Subject: DRIVER AND/OR PASSENGER SEAT WARMER(S) INOPERATIVE - (CLOTH SEATS ONLY)	Bulletin No.: 09-017/18
	Last Issued: 03/26/2018

2013-2016 CX-5 vehicles equipped with cloth seats.

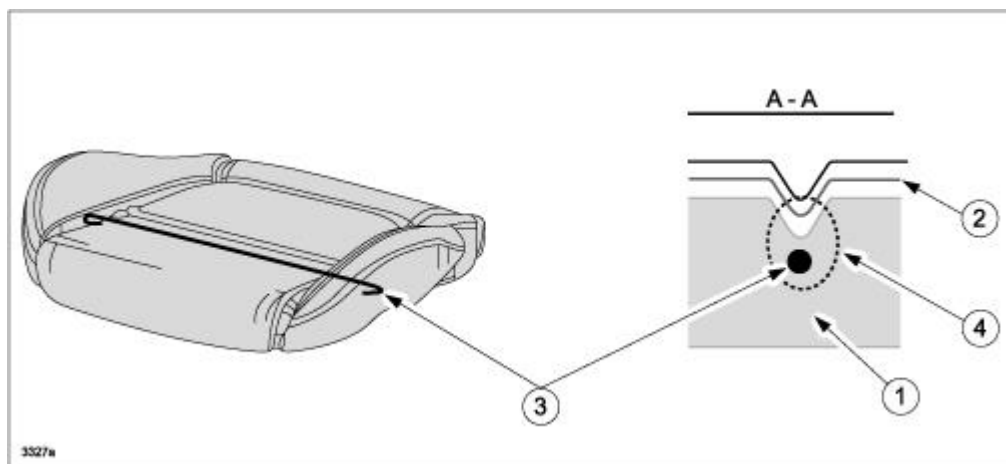
Some vehicles may exhibit **inoperative** driver and/or front passenger side seat warmer(s) in any mode (High, Mid and Low). This may be caused by repeated load applied to the seat cushion (1) while the seat is occupied. A section of the heater mat (2) just above the reinforcement rod (3) in the cushion pad contacts internal heater mat wire and causes damage (4).

1. Verify the **customer concern**.
2. Replace the seat cushion pad(s) **according to the instructions on MGSS online** FRONT SEAT CUSHION TRIM REMOVAL/INSTALLATION.

NOTE: A new seat cushion pad is available with a repositioned internal heater mat wire to prevent contact with **the** reinforcement rod.
